MDB1175 (WVA 20753) / MDB1883 (WVA 23103)

Mintex is harmonising the two references MDB1175 and MDB1883. MDB1883 will cover applications of both part numbers in the future. Therefore MDB1175 will be phased out.

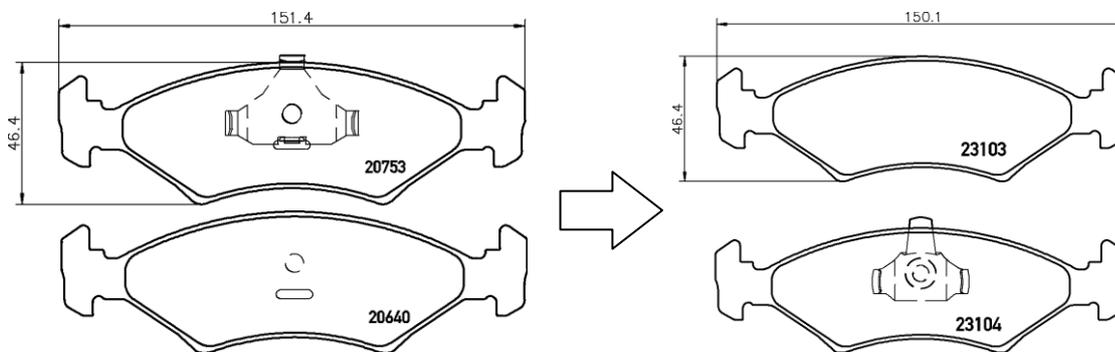
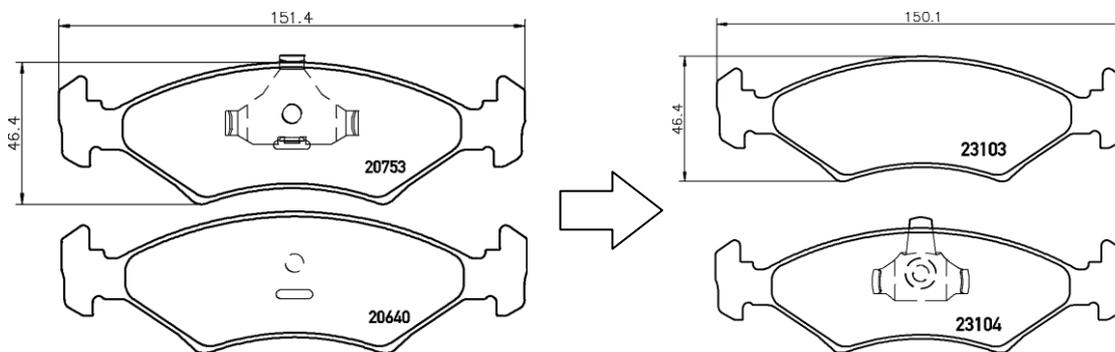
The parts differ in the way the piston clip is mounted on the back plate. Furthermore, the overall length of MDB1883 is a bit smaller so that the pads can be fitted to those vehicles which previously used MDB1175, without any problems.

Existing stock of MDB1175 can be sold without any problems.
